Service Bulletin #SB025

**Subject: Grab Handle Fasteners Inspection and Replacement (where necessary)**

**Models Affected: Units listed in enclosed document**

ORIG BY: GPB	PROG. NO. -	MATERIAL -	MATERIAL DESCRIPTION -			
ORIG DATE: 10/30/2018	PROG. BY -	MAKE FROM -	PART YIELD -	SIMILAR TO -	SCALE 1:1	
CHK BY: -	PROG. DATE -	FINISH -	WEIGHT -	DWG. NO. -	SIZE A	
CHK DATE: -	TITLE GRAB HANDLE FASTENER REPLACEMENT KIT			PART NO. 104689-SDR25	REV IR

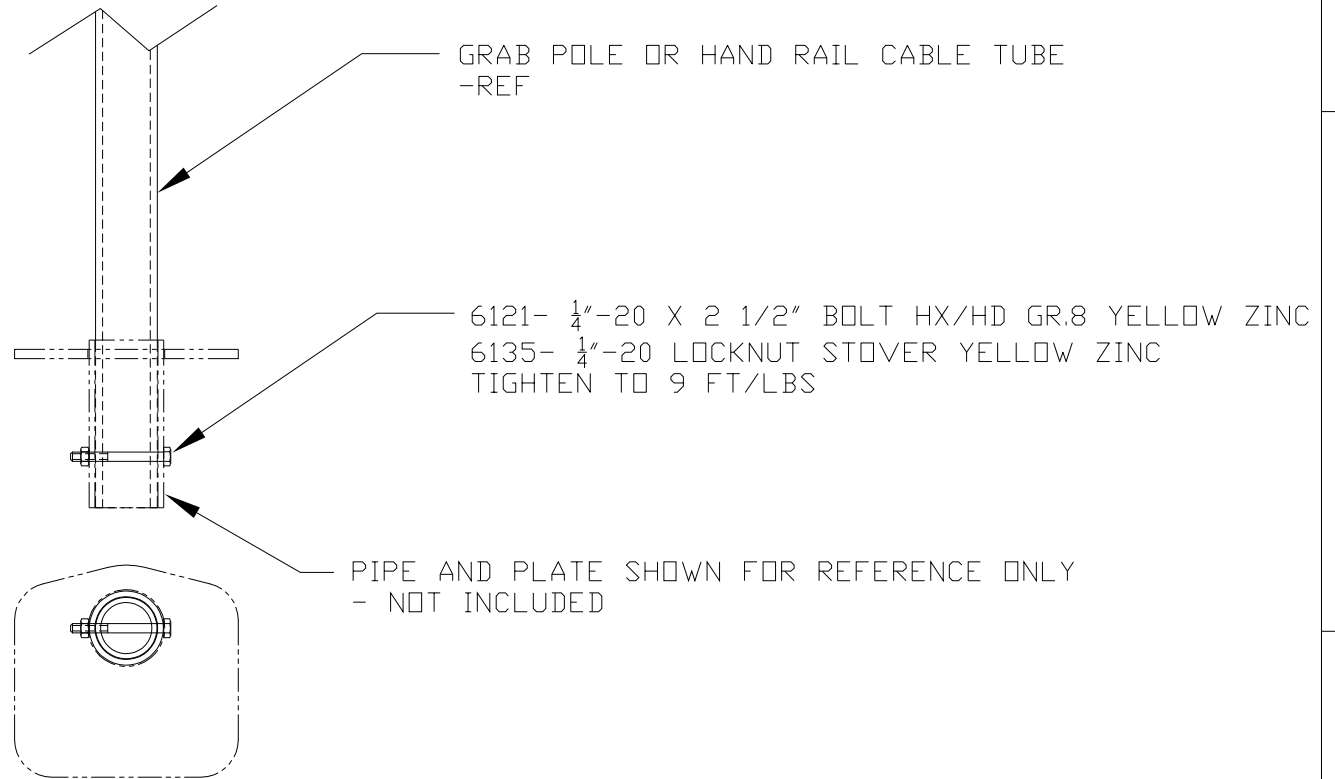
3. Schedule unit for repairs at the Cottrell Service Center or any Authorized Cottrell Warranty Repair Facility for Service Bulletin #025.
4. Have repair center remove rivets from both sides and replace with bolt and nut per drawing#104689-SOR25. If hole(s) have elongated or wallowed out, drill out the holes and install the next larger size bolt using the torque values set forth on the enclosed drawing.

1. REMOVE RIVETS
2. INSTALL  $\frac{1}{4}$ " BOLT AND NUT AND TIGHTEN TO 9 FT/LBS.
3. IF HOLES ARE ELONGATED OR WALLLOWED-OUT THEN DRILL TO THE NEXT LARGER SIZE AND USE APPROPRIATE SIZED BOLT AND NUT - USE THE FOLLOWING TORQUE VALUES:

$\frac{5}{16}$ "-18 X 2 1/2" - 20-30 FT-LBS

$\frac{3}{8}$ "-16 X 2 1/2" - 30-40 FT-LBS

# Condition of Rivets - Bad/To Be Replaced

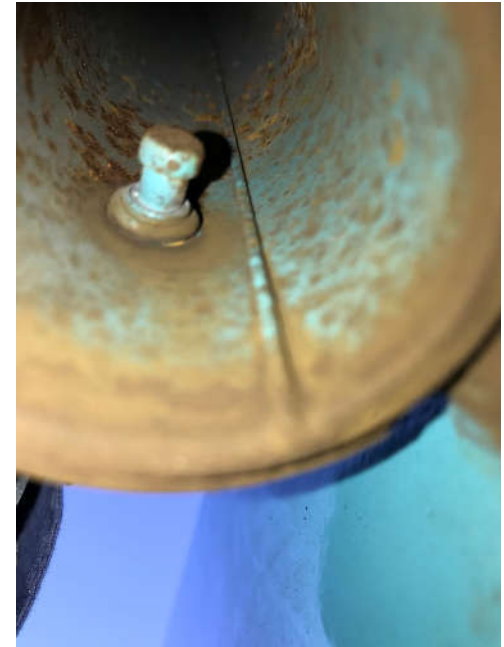
1. Inspect all Grab Handle Fasteners on affected units to identify rivet(s) that are loose, missing, sagging, missing the center pin, or otherwise damaged or appearing as though they were not installed correctly. See enclosed photographs to determine condition of rivets.
